City of Richmond Department of Planning & Development Review

PROPOSAL: Final Review of Warwick

Road Maintenance Facility

Warwick Road Maintenance Facility Improvements – UDC Narrative

UDC Recommendations for Final Design:

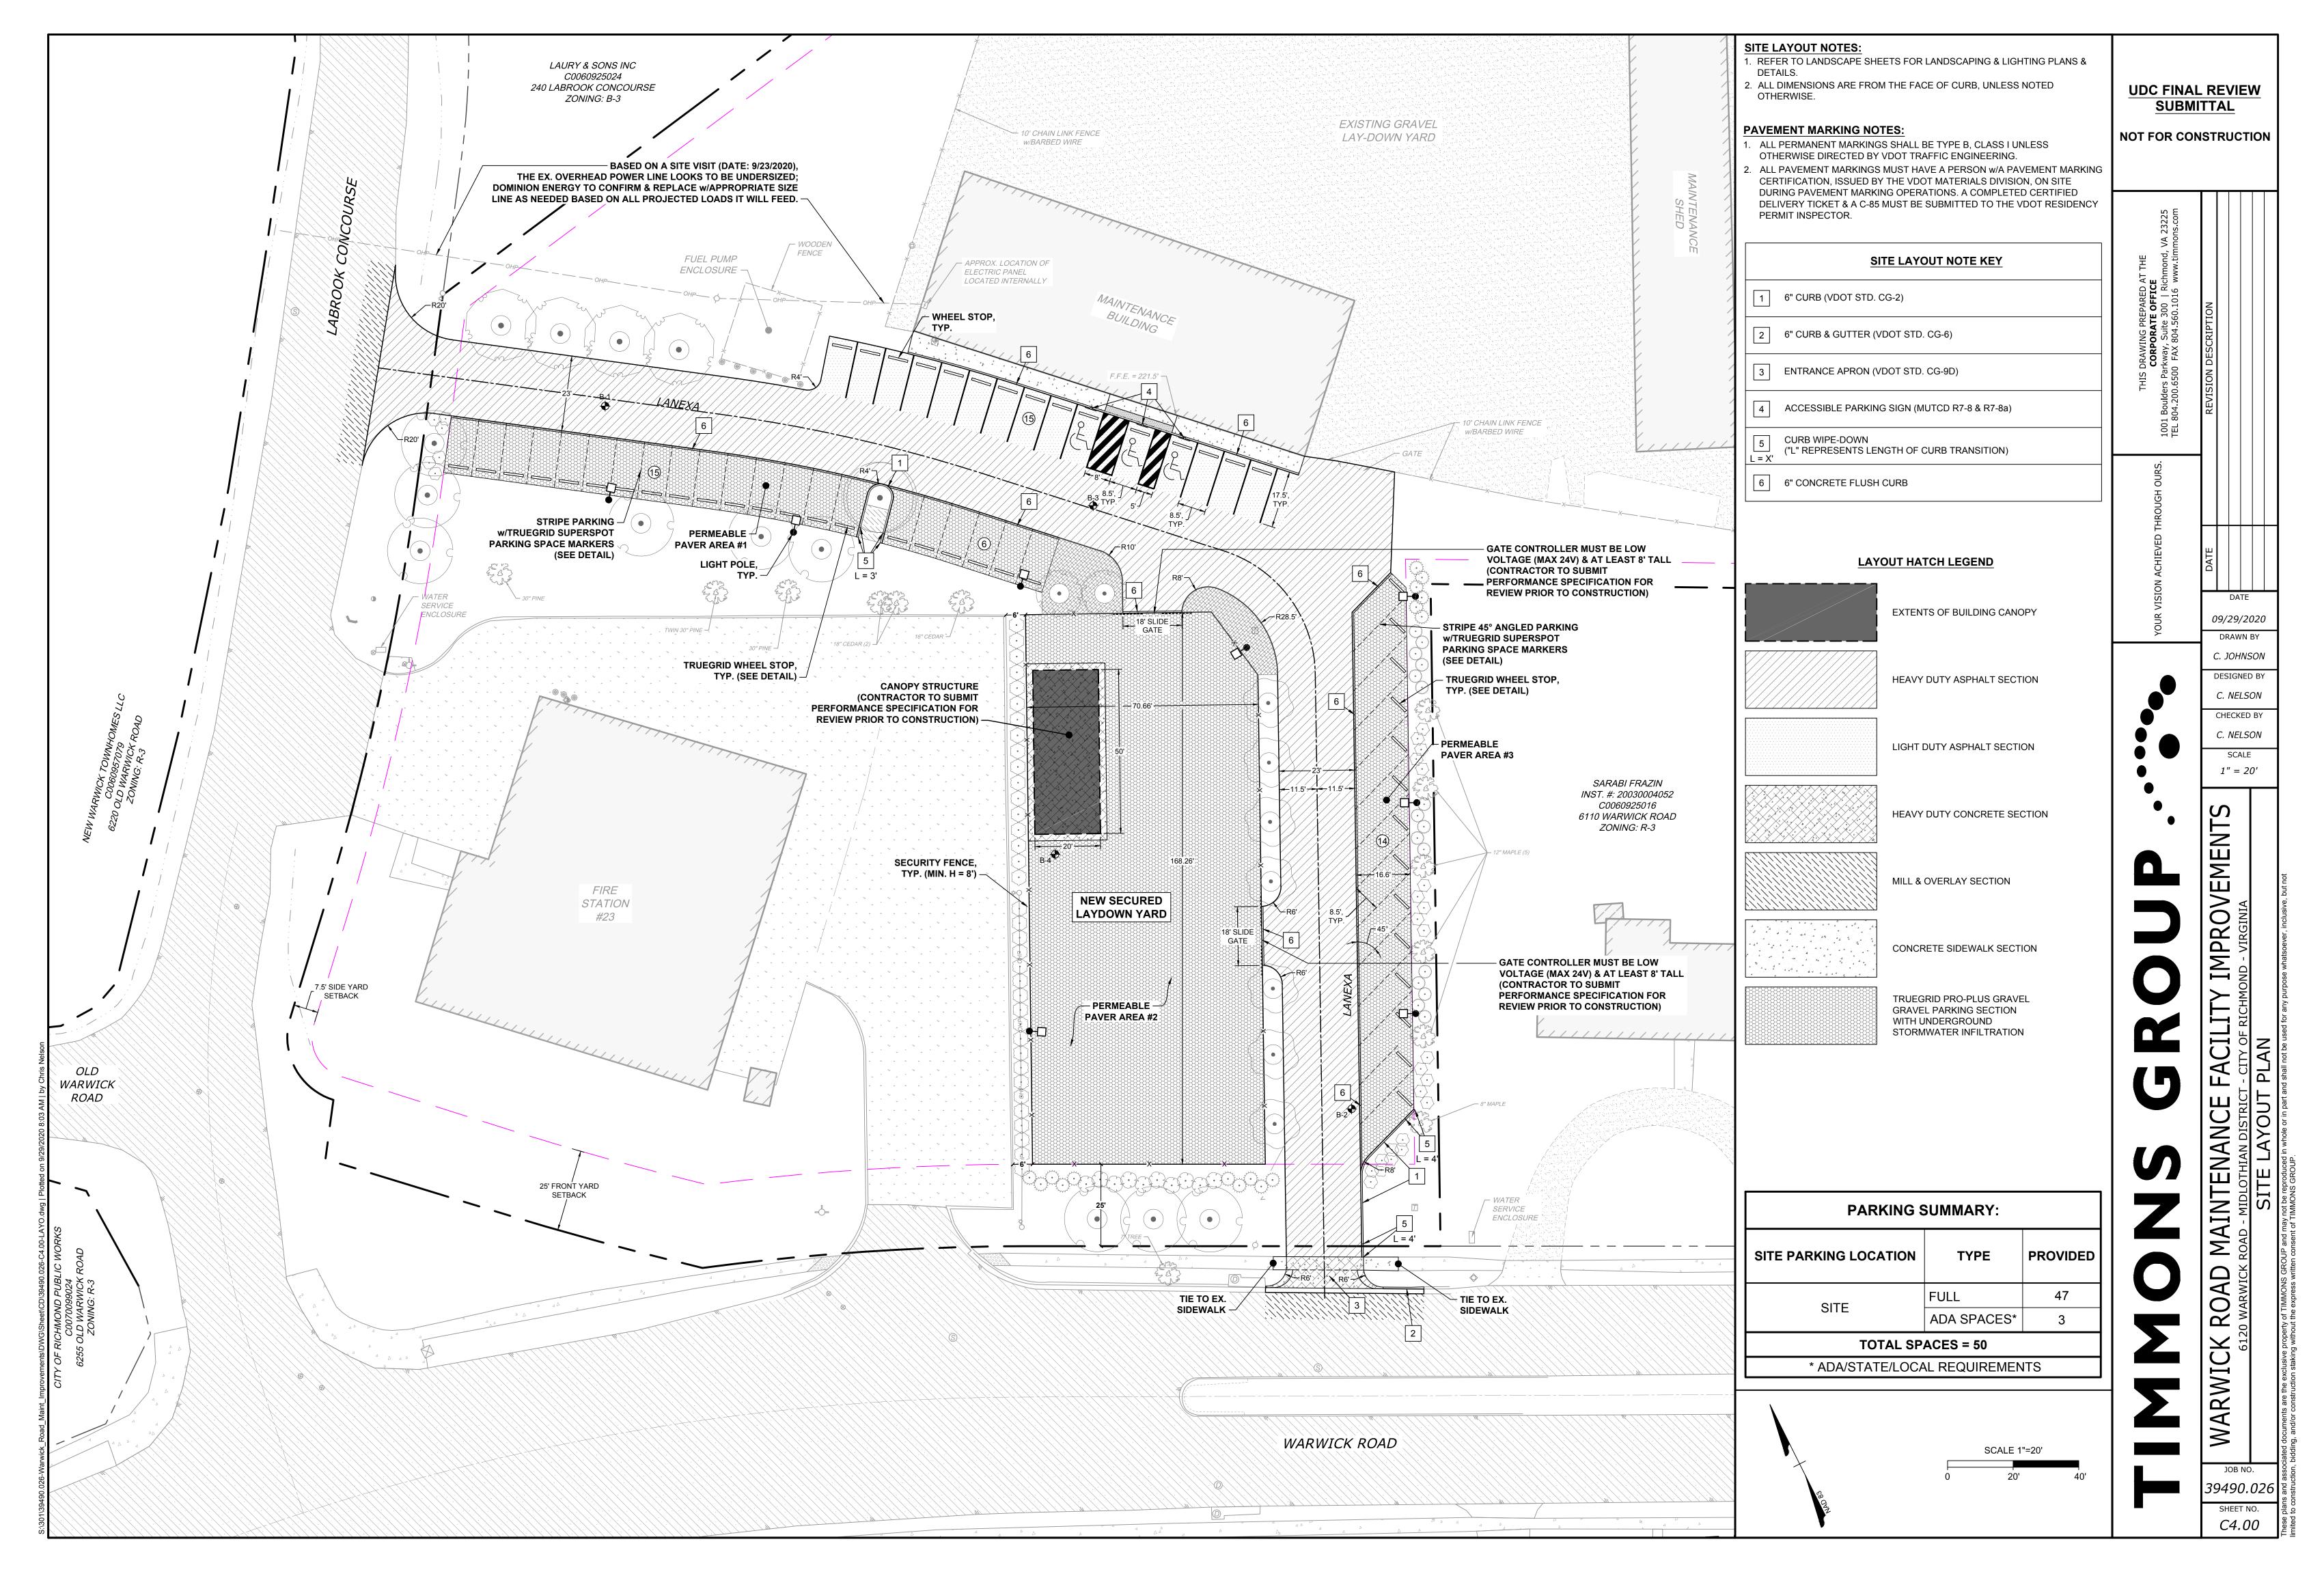
- Applicant consider pervious paving materials for the parking spaces in front of the maintenance building.
 - √ TrueGrid permeable pavement is now being proposed in 3 specific areas of the site: laydown yard, angled parking spaces to the east, and the parking spaces closest to the fire station parking lot.

- The new fencing installed as screening around the new lay-down yard be wooden and stained a neutral color.
 - ✓ Due to the nature of the proposed use within the laydown yard, and in an effort to keep overall project costs down, a more secure and cheaper fence type will be used. The project is proposing to use black vinyl coated chainlink fence.

- Larger shade trees proposed in the landscape plan be prioritized on the west and south side of the new lay-down yard to further enhance screening from Warwick Road.

- ✓ The top of the TrueGrid permeable pavement is installed with a rigid system to enhance stabilization of aggregate fill material.
- Applicant consider the feasibility of locating the new canopy structure to the northeastern portion of the lay-down yard, away from Warwick Road, so that it may be less visible from the main road.

- √ This recommendation was adhered to and is reflected in our current landscape plan.
- For gravel parking spaces, if grade allows, applicant consider setting first layer of gravel in a stabilizing grid to further protect the gravel from being washed away.

- ✓ The proposed canopy structure has been relocated within the laydown yard in an effort to reduce its visibility from Warwick Road.
